19-101PP – Oak Park, Subarea E – Preliminary Plat

This is a request for review and recommendation of approval to City Council for a preliminary plat of a ±3.5-acre site within the Oak Park neighborhood to facilitate the future construction of up to 12 single-family homes and 0.66-acre of open space in two reserves.

Site Plan

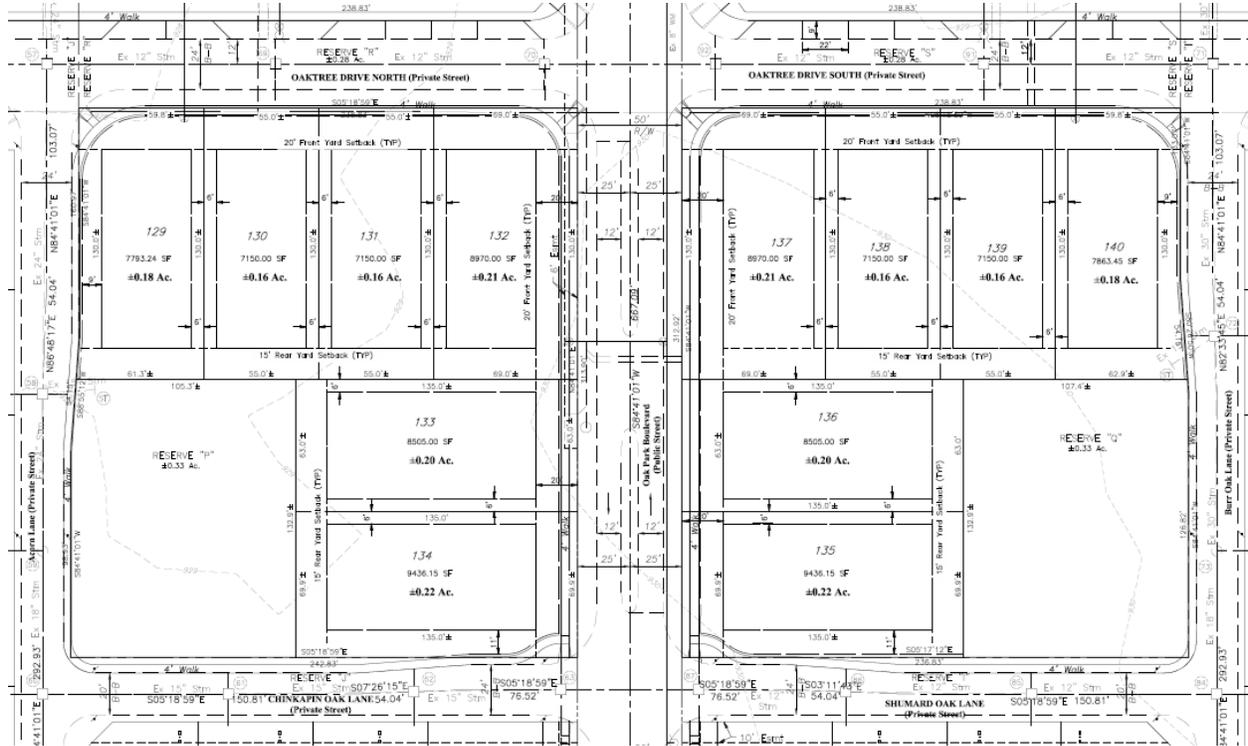
The applicant is proposing 12 new parallel parking spaces on the east side of Oak Tree Drive North/South. These parking spaces do not meet Code with regard to length/width and staff recommends the drawings be revised to reflect the correct dimensions prior to review and determination of the Preliminary Plat by City Council. The proposal is for 9-foot by 22-foot spaces, where 10-foot by 23-foot spaces are required.

The applicant proposed sidewalk improvements outside of the boundaries of the plat. Staff recommends that the applicant continue to work with staff to ensure that all improvements are made within the geographic boundaries of this plat prior to the final plat.

- 1) The applicant ensures that any minor technical adjustments and updates to the plat in accordance with the accompanying Preliminary Development Plan are made prior to City Council submittal; and,
- 2) That the applicant continue to work with Staff to ensure that all improvements are made within the geographical boundaries of this plat prior to review and recommendation of the Preliminary Plat by City Council; and,
- 3) That the applicant revise the drawings to reflect the correct on street parking dimensions prior to review and determination of the Preliminary Plat by City Council.
